**IN THE MATTER** of an application to Hamilton City Council for Private  
Plan Change 7 to the Hamilton City District Plan by  
Green Seed Consultants Limited

**STATEMENT OF EVIDENCE OF ALASTAIR JAMES BLACK**

**Dated 22 October 2021**

**Figure 1: Google Traffic from SH39 (Thursday 14 October 2021, 8am)**

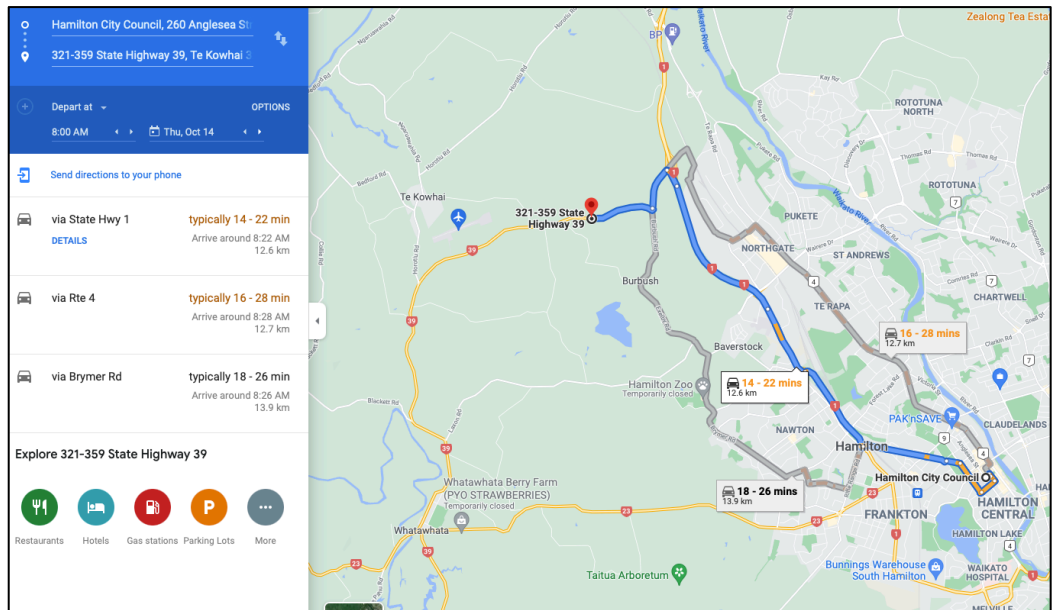
28. From my review of the model outputs I note that:
  - a. In the 150 and 500 dwelling scenarios the majority of trips are using SH39 Koura Drive and SH1 over Burbush and Exelby Roads. With the initial stages of development accessed via the proposed SH39 roundabout this is the shortest and fastest route to the

**Figure 2: Google Traffic from Burbush Road (Thursday 14 October 2021, 7.58am)**

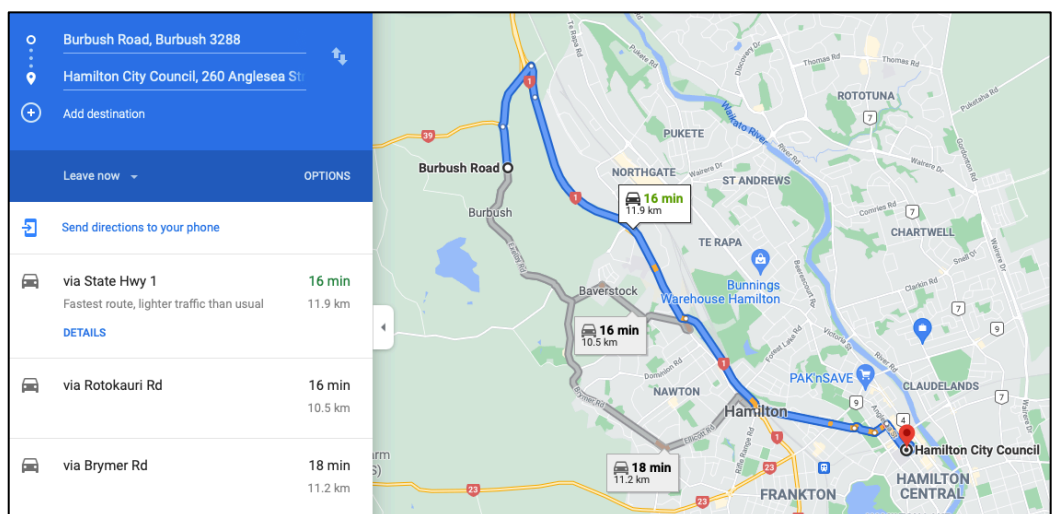
- b. The connection of the Plan Change area to Burbush Road results in the Exelby Road/ Burbush Road route having a shorter distance and similar travel time to SH1. This is illustrated in the following image from Google Maps. In my opinion, this indicates that route selection will be heavily influenced by driver behaviour and perceptions.

**Figure 3: Google Traffic from Exelby Road via SH1 (Thursday 14 October 2021, 8am)**

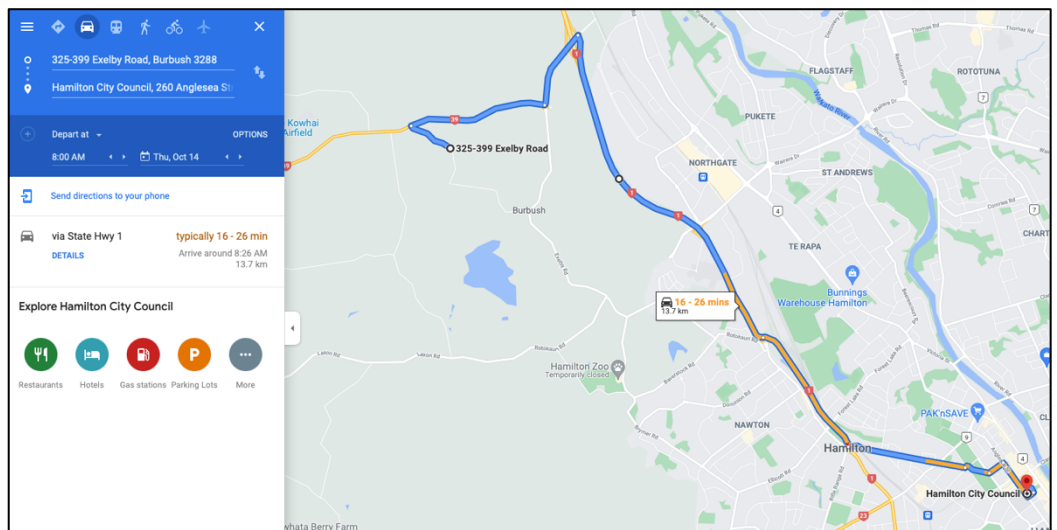
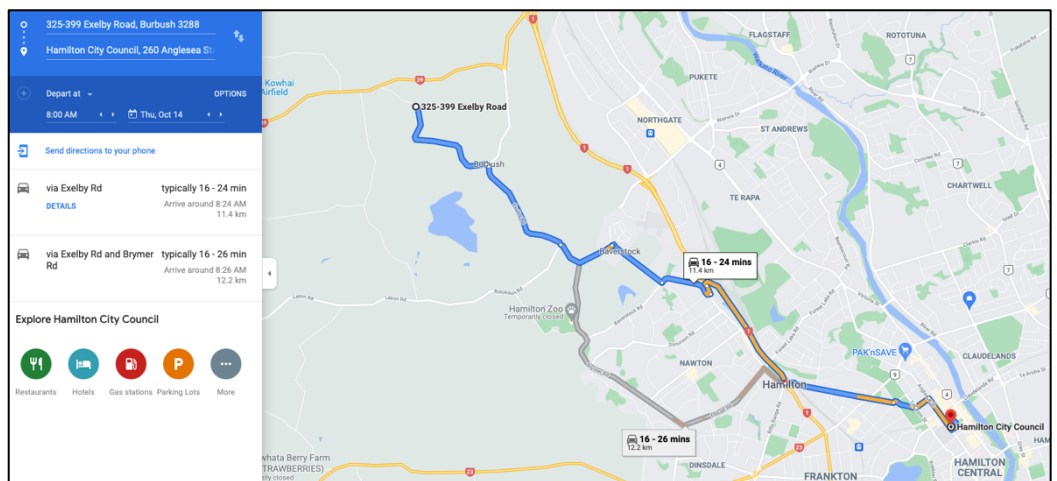
- c. Once a connection to Exelby Road is provided the travel time from this intersection to the Hamilton CBD is very similar (16-26mins). However the travel distance is shorter, 11.4-12.2km via the local roads compared to 13.7km via SH1. In my opinion, this indicates that route selection from the western side of the Plan Change area will be heavily influenced by driver behaviour and perceptions.

**Figure 5: Modelled Traffic Volume on Exelby Road**

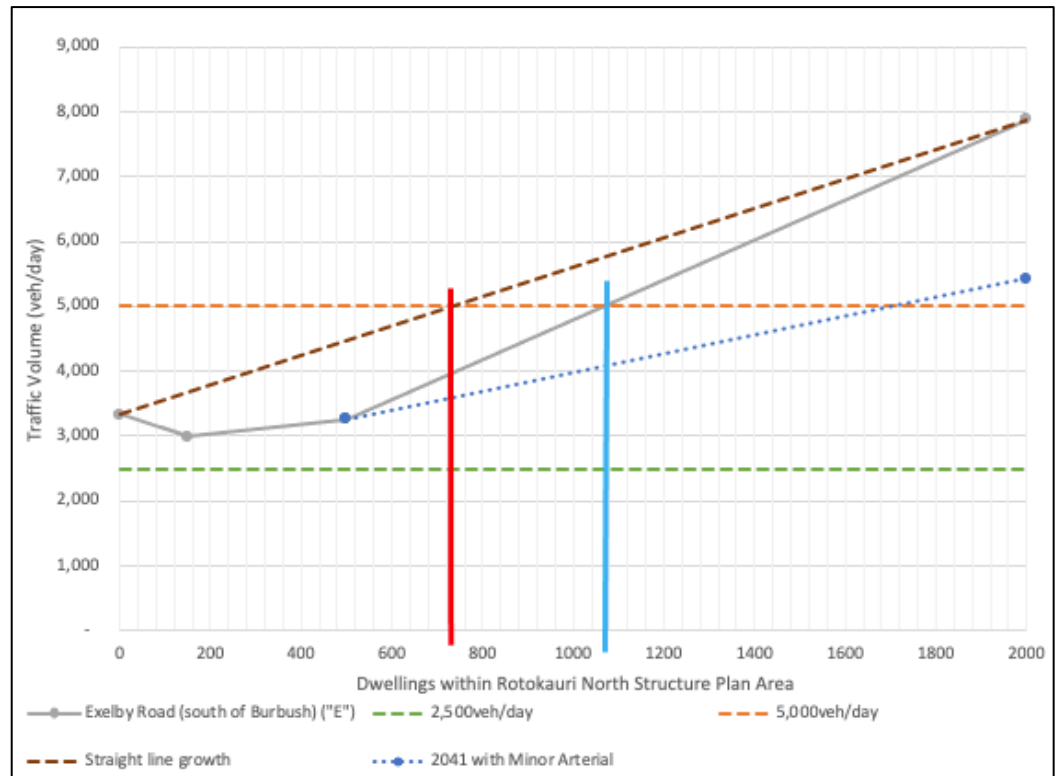
41. Using the methodology above, the predicted injury crash rate for a 7.7m sealed width increases to 1 injury crash per year with a traffic volume of approximately 5,000veh/day. As shown on the figure below, this equates to development of around 700 to 1,000 dwellings. If traffic volumes growth linearly between the base and 2,000 dwelling scenarios, the trigger is 700 dwellings (red vertical line on the figure below). This increases to approximately 1,000 dwellings based on the traffic model outputs (blue vertical line).

42. On the figure below, the blue dashed line shows linear traffic growth from the 2021 scenario with 500 dwellings to the 2041 scenario with the minor arterial in place. However, the timing for construction of this infrastructure is uncertain. In the future 2041 scenario, the traffic volume is close to 5,000veh/day threshold described above and no further upgrade would be triggered.

**Figure 7: 2041 PM Peak Flows**

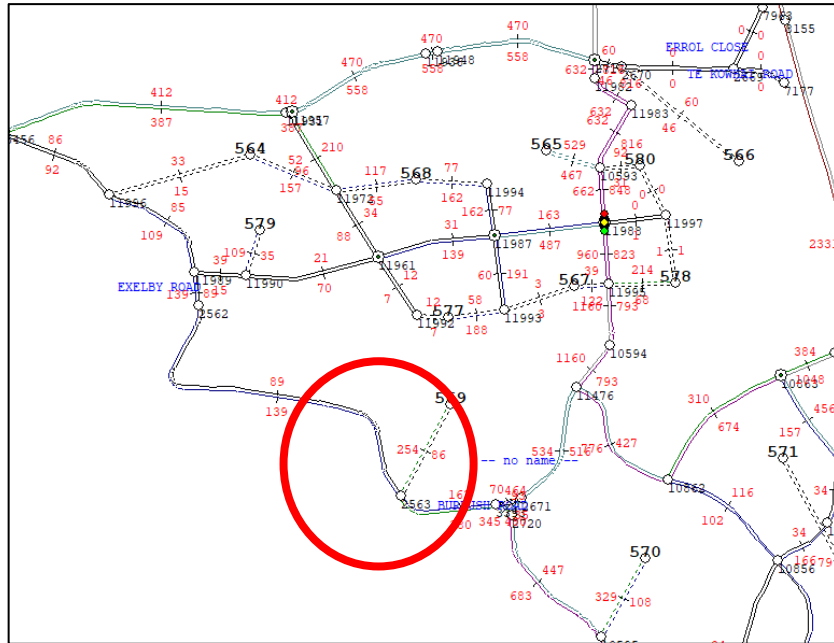
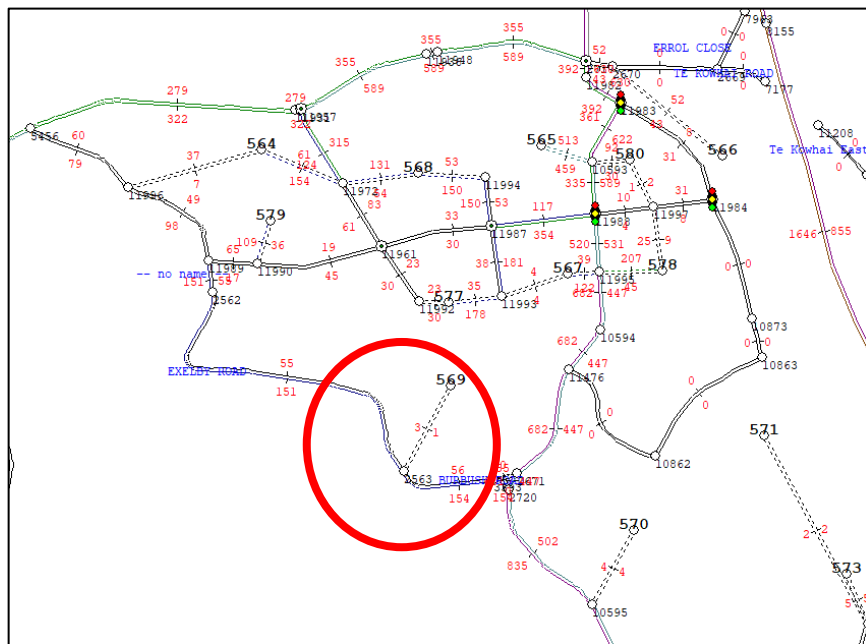
56. I have reviewed the revised modelling attached to JWS #4 to further understand the turning movements at this intersection. Comparison of these model outputs to those attached to the revised ITA show that the majority of the turning movements are associated with future development of the property south of the Plan Change area. As shown in the figures below, the model loads all traffic from this area to Exelby Road via node 569 which results in right-turn demand at the Exelby Road/ Burbush Road intersection.

**Figure 9: Rotokauri Structure Plan (Figure 2-8)**

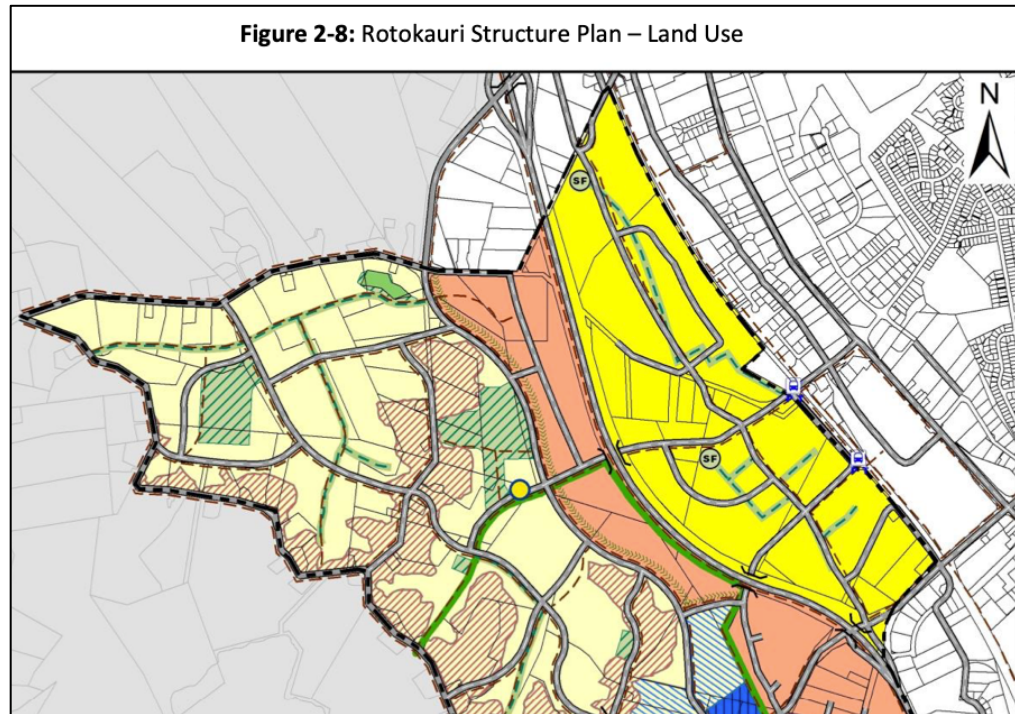
82. While Mr Wood's evidence<sup>50</sup> is focused on the shared path connection to the SH39/ Burbush Road roundabout, I consider his comments on the Hamilton-Waikato Metro Area Mode Shift Plan<sup>51</sup> are also relevant to the provision of walking and cycling facilities within the structure plan area.

84. An active mode network should be illustrated on the Structure Plan map to aid interpretation and future assessment of walking and cycling. However,
